From: Cherne, Curtis
Sent: Friday, October 12, 2012 7:53 AM
To: 'Ron Bohannan'
Cc: 'James K. Trump Jr.'; 'kwveritas@live.com'; 'Derek Bohannan'; 'bfrosch@tierrawestllc.com'
Subject: RE: 4910 Union Way Illegal Dumping Tract 1-A Renaissance Center

Re: First Family Church Conceptual Grading and Drainage Plan
Engineer's Stamp dated 8-18-04, (F16/D15)

RE: RENAISSANCE APARTMENTS PHASE 1 AND 2 (F16-D5). DRAINAGE REPORT FOR SITE DEVELOPMENT PLAN FOR SUBDIVISION, SITE DEVELOPMENT PLAN FOR BUILDING PERMIT, FINAL PLAT, AND BUILDING PERMIT APPROVALS. ENGINEER'S STAMP DATED NOVEMBER 7, 1997.

DRAINAGE REPORT
FOR

NORTH
SHEET: PD-1
REV: 0

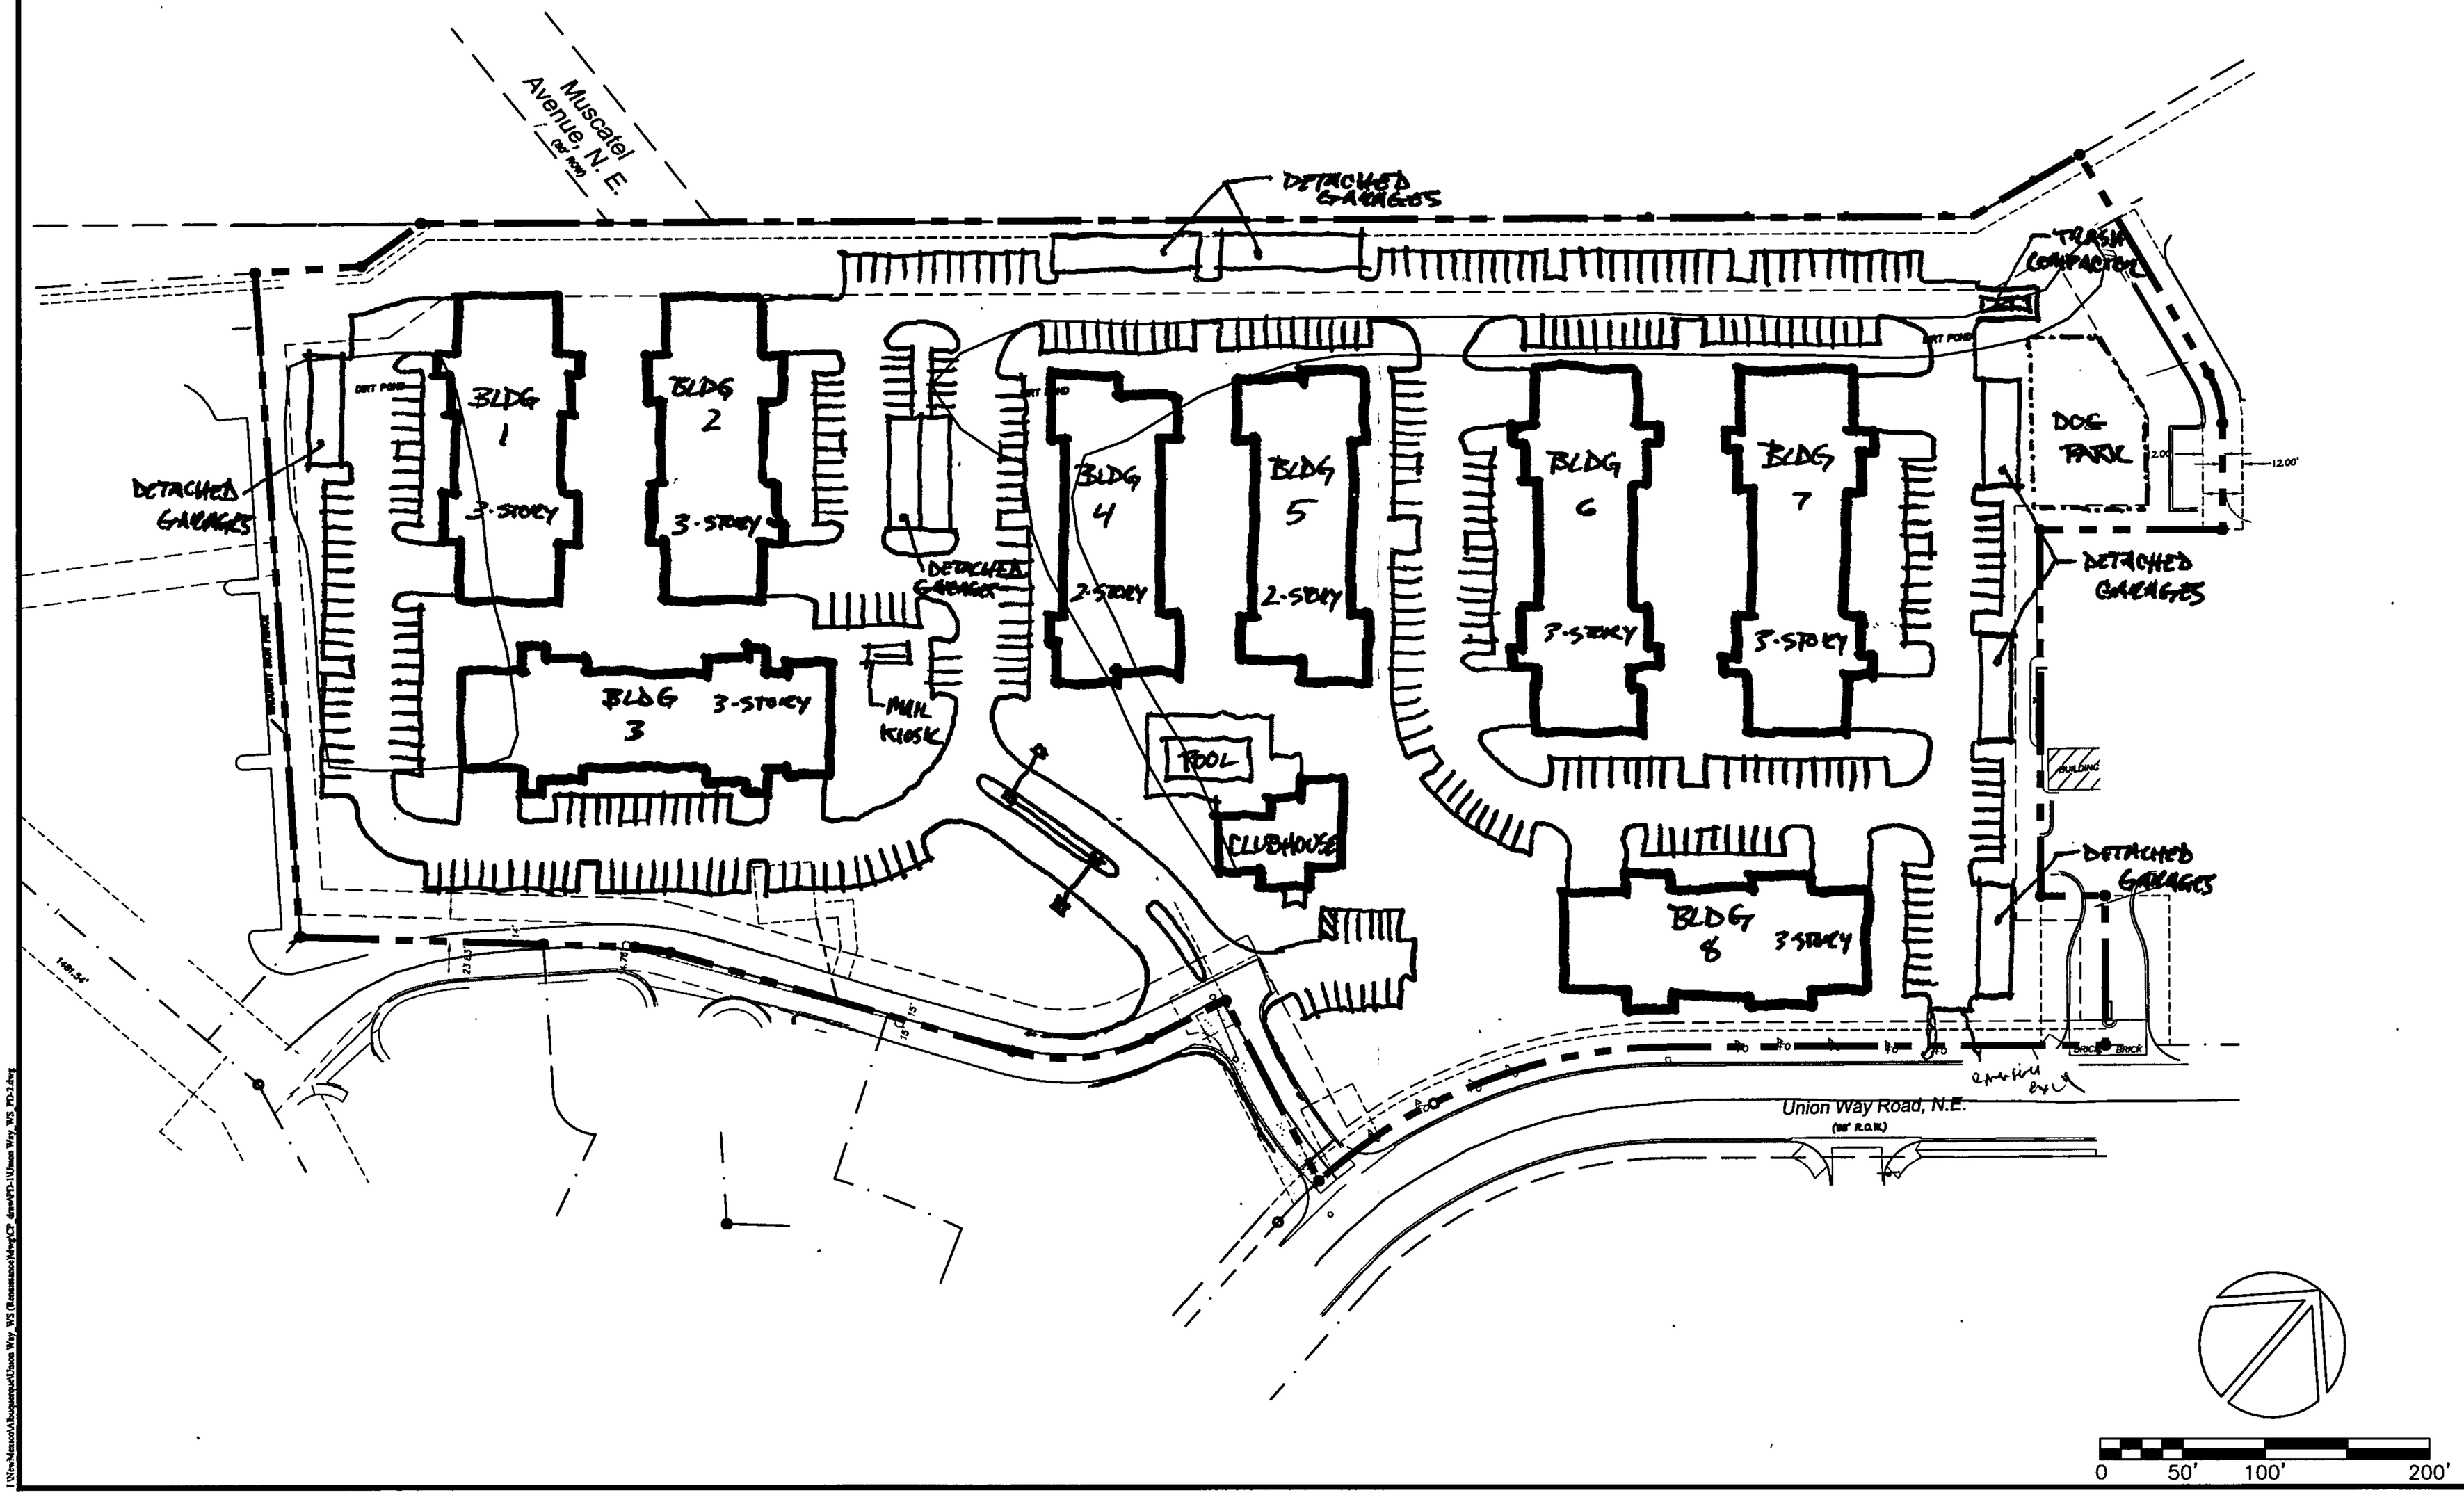
build all at one time? or phase?
clubhouse first CO?

who cleans dog park or pond it? they do
as well as residents

0.1 cfs/acre acknowledged

grading plan ~~to~~ w/ TCL to be phased
to coordinate with CO.

Submit TCL and grading plan
1 month prior to permit set
submittal
